Delegated Report

Householder Planning Application

Planning Application No: 20230841

Description: Creation of vehicular access onto Livingstone Road with access over a grass verge and tarmac drive.

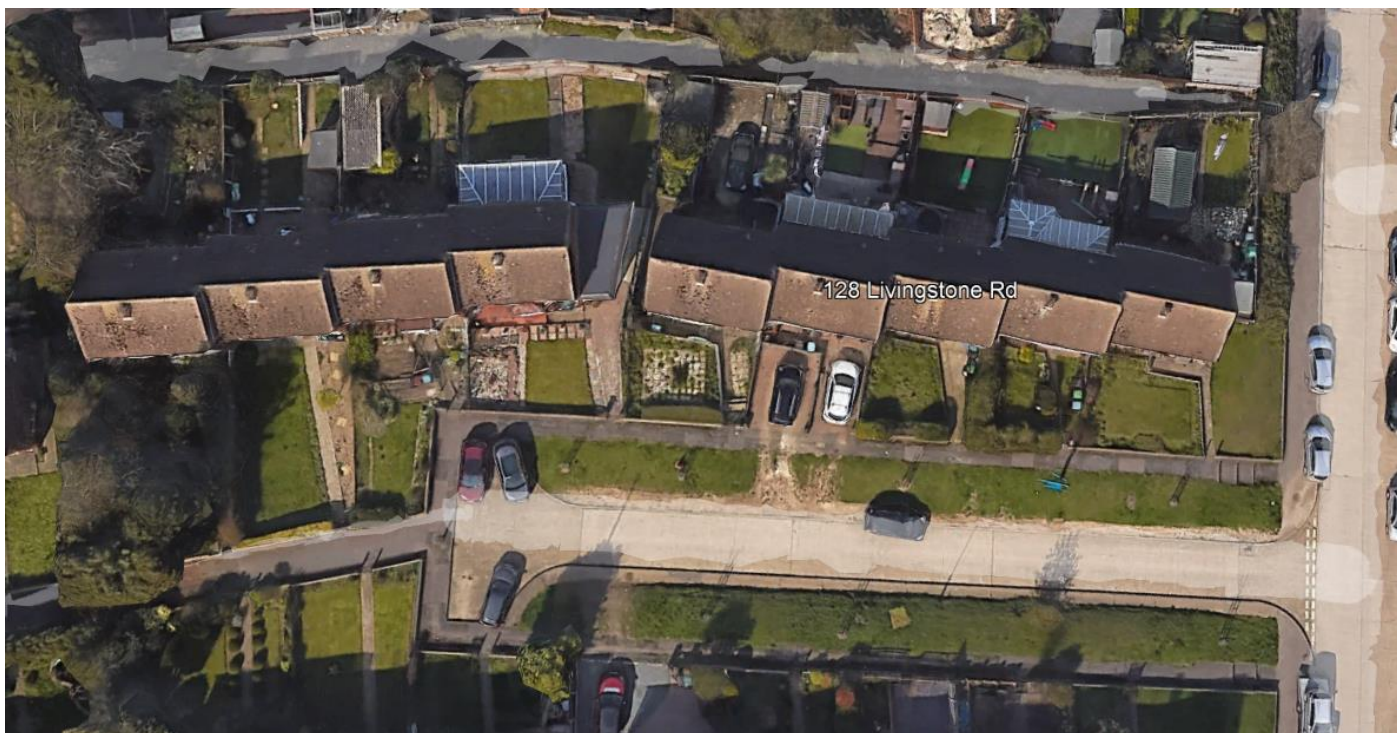
The proposal seeks to create a vehicular access onto Livingstone Road with access over a grass verge. This is shown below and it should be noted that the engineering works have to the front of the property has been completed.

The grass verge is considered to contribute significantly to the character of the area and is consistent feature throughout the cul-du-sac. It is acknowledged that the quality of the grass verge in front of the application site has been eroded by unauthorised vehicles crossing over the grass verge.

It is considered that the loss of the grass verge, by virtue of creating a crossover and hardstanding would fail to conserve or enhance the character of the area and will detrimentally impact on the appearance of the street scene.
